XAVIER  
KNIGHT

## Civil Engineering Statement – Response to Council RFIs

24,26 & 28 Middle Harbour Road, Lindfield

The Proponent has received feedback dated 23<sup>rd</sup> of April 2026 from Ku-ring-gai Council following the submission of the Xavier Knight's civil engineering documentation as part of the EIS submission for the SSD (SSD-82548708).

Civil Engineering Plan C03003

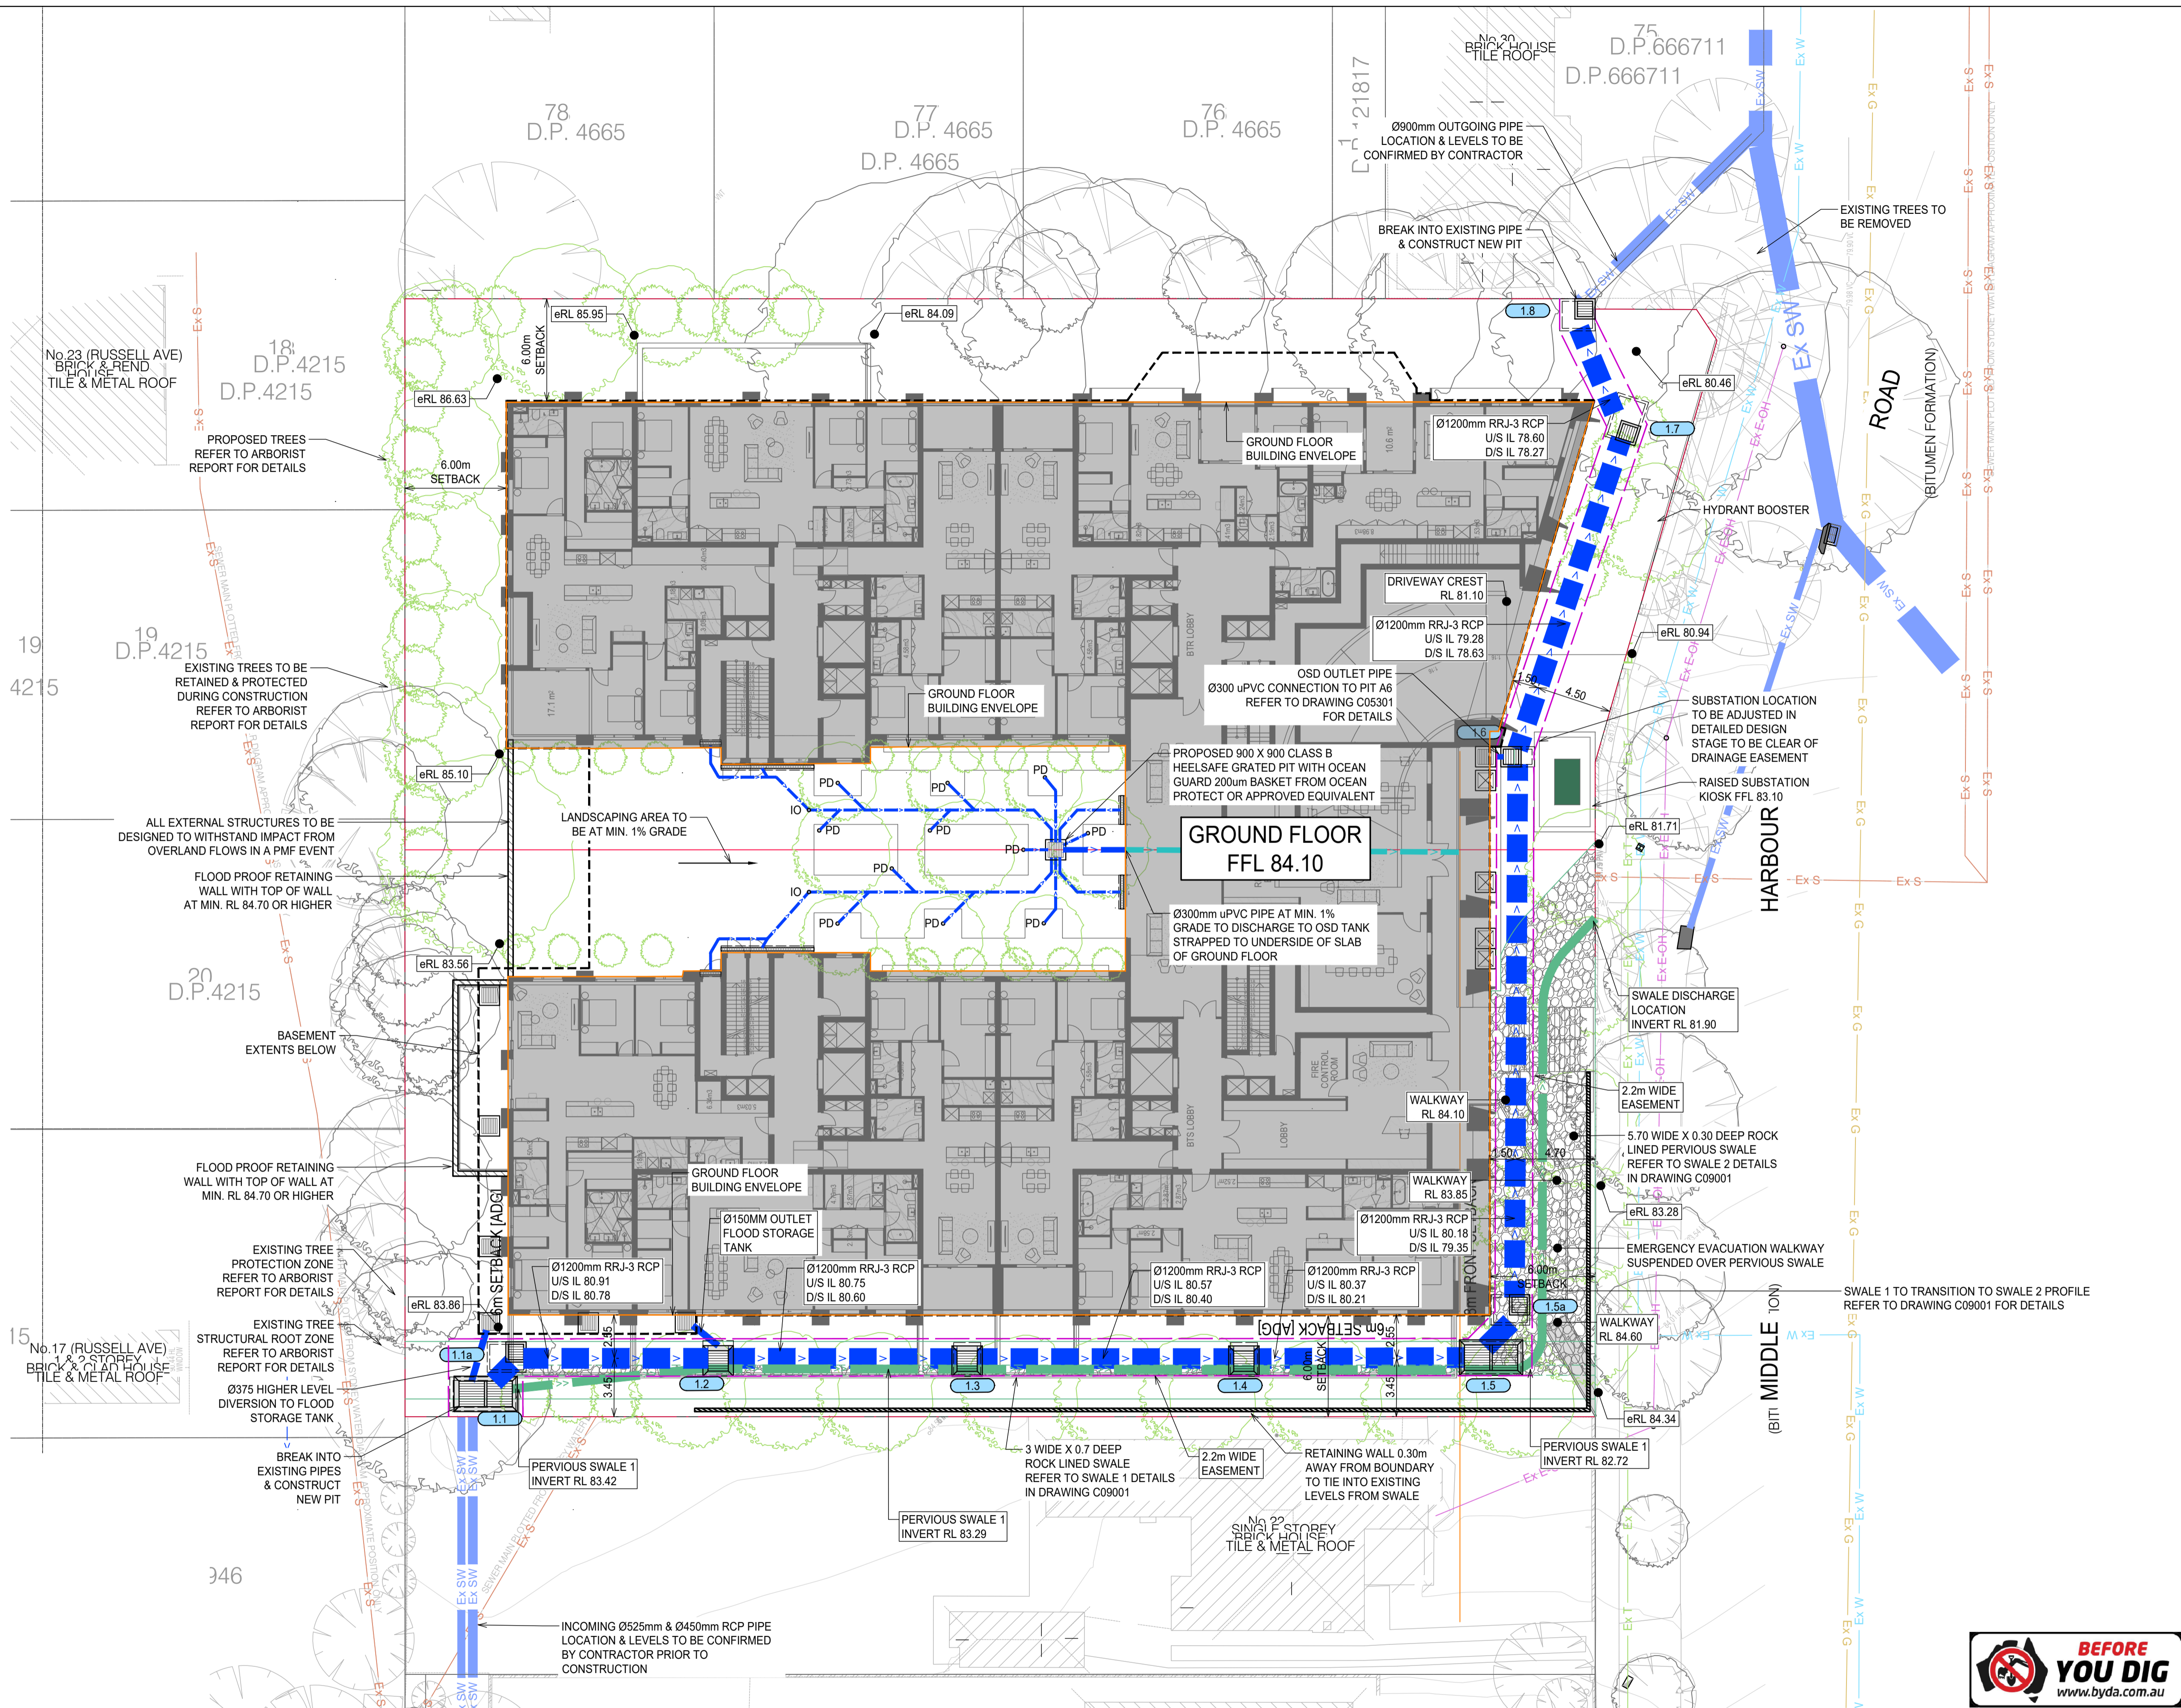
No.	Key Assessment Issue	Response
<b>Civil Plans</b>		
1	Approval from Council's Engineers within the Operations Department is required for the realign/divert Council's existing pit and pipe system. At this stage there is no approval for the works to discharge stormwater and/or realign Council's trunk drainage system.  - The submitted plans do not identify the location or extent of the proposed drainage easement, only the proposed pipeline alignment. (Not Resolved)	Refer to <b>Appendix A</b> of this statement for revised civil engineering plan C03003 showing the extent of a 2.2m wide dedicated easement over the proposed drainage diversion. The width of the easement has been determined in accordance with KDCP Part 24R.2.
2	Council's Operations Team have advised that the proposed trunk drainage diversion/re-alignment cannot be supported given that this design has several deviancies which is considered unacceptable and non-compliant.  Council's Operations Team has previously advised that the proposed trunk drainage diversion/realignment is not supported due to multiple design deviations. (Not resolved)  <u>Key outstanding issues include:</u>	Refer to <b>Appendix A</b> of this statement for revised civil engineering plan C03003 showing 90 degree bends have been replaced with 2 x 45 degree changes in directions.  Refer to <b>Appendix A</b> of this statement for revised civil engineering plan C03003 showing the extent of a 2.2m wide dedicated easement over the proposed drainage diversion. The width of the

No.	Key Assessment Issue	Response
	<ul style="list-style-type: none"> <li>- In the proposal, 90-degree system direction change was proposed. Council does not endorse this type of design. Modification is required to the 90-degree pits.</li> <li>- No details of easement over the proposed drainage system. The width of the easement shall be depicted in accordance with Part 24R.2 of the KDCP.</li> <li>- It is unclear the distance between the proposed building and drainage system. Council requires the proposed building will not be located within "zone of influence" of Council drainage system.</li> <li>- The data provide in "Integrated Water Management Plan" (page 39) "pit 1.4 floods", which indicate that the system could not convey 5% storm event. The detailed calculation is required.</li> <li>- The connections between OSD and Trunk drainage system in the proposal was not clear. Does the OSD have a 1200 mm pipe connection with 1200 mm trunk drainage? Clarification is sought.</li> </ul>	<p>easement has been determined in accordance with KDCP Part 24R.2.</p> <p>Refer to <b>Appendix A</b> of this statement for revised civil engineering plan C03003 which marks the proposed offset from the site boundary and building line. As the shoring wall will transfer building loads into the underlying bedrock, the shoring system will not impose any load on the proposed stormwater arrangement.</p> <p>This is a misinterpretation of the DRAINS data table in Appendix B of the Integrated Water Management Report dated 04.03.2026. For the row with Pit 1.4 information, the label 'FLOOD.S' refers to the connecting modelling node for the 'Flood Storage Tank' which forms part of the 1% AEP stormwater management system. Columns 30 and 31 of the results table show that for Pit 1.4 the peak water levels for the 5% and 1% AEP events are RL81.83 and RL82.25 respectively. These levels are lower than the proposed pit grate level of RL82.92. As such no flooding or surcharging occurs at Pit 1.4</p> <p>Refer to <b>Appendix A</b> of this statement for revised civil engineering plan C03003 showing the 300mm diameter connection from the OSD outlet to the proposed diversion pipe.</p>

3	<p>The proposal seeks to discharge the stormwater runoff created by the new development into Council's existing trunk drainage system which is located within the site. This trunk drainage system traverses diagonally through the property. The applicant has indicated that they wish to realign/divert Council's existing pit and pipe system to cater for the proposal. This cannot be supported in its current format as it is a major burden to Council's infrastructure and long-term</p>	<p>Refer to CCTV footage dated 04.06.2025 of the existing stormwater assets. The footage shows the section traversing the proposed development site is heavily impacted by accumulation of silts, debris and damage from tree roots. The 1200mm pipe size has been selected as it is able to cater for the combined upstream flows from the 450mm and 525mm pipes, while also providing improved capacity to remove runoff</p>

No.	Key Assessment Issue	Response
	<p data-bbox="544 394 1023 454">maintenance, ongoing system failure, deficient pipe sizing etc of the trunk drainage system.</p> <ul data-bbox="544 495 1023 853" style="list-style-type: none"> <li data-bbox="544 495 1023 752">- The applicant proposes increasing the pipe size from 900 mm to 1200 mm. However, the upstream inflows comprise 525 mm and 450 mm pipes, with the downstream connection reverting to a 900 mm pipe. According to the response the downstream and upstream pipe is in good condition, but no supporting reports or any CCTV videos has been provided.</li> <li data-bbox="544 792 1023 853">- No longsections for the drainage drawings have been submitted.</li> </ul>	<p data-bbox="1054 394 1463 454">from the surface which now be instead conveyed by the underground system. Our DRAINS model is able to demonstrate that the connection between the 1200mm pipe and the existing 900mm pipe does not result in any additional ponding or surcharging at the point of connection and there is no impact to upstream or downstream hydraulic performance during the 5% and 1% AEP storm events.</p> <p data-bbox="1054 792 1463 1021">Longitudinal sections with Hydraulic Grade Line analysis have been provided in Section 3.8 of the Integrated Water Management Plan report. A detailed longitudinal section will be prepared as part of the Design Development phase of the project.</p>
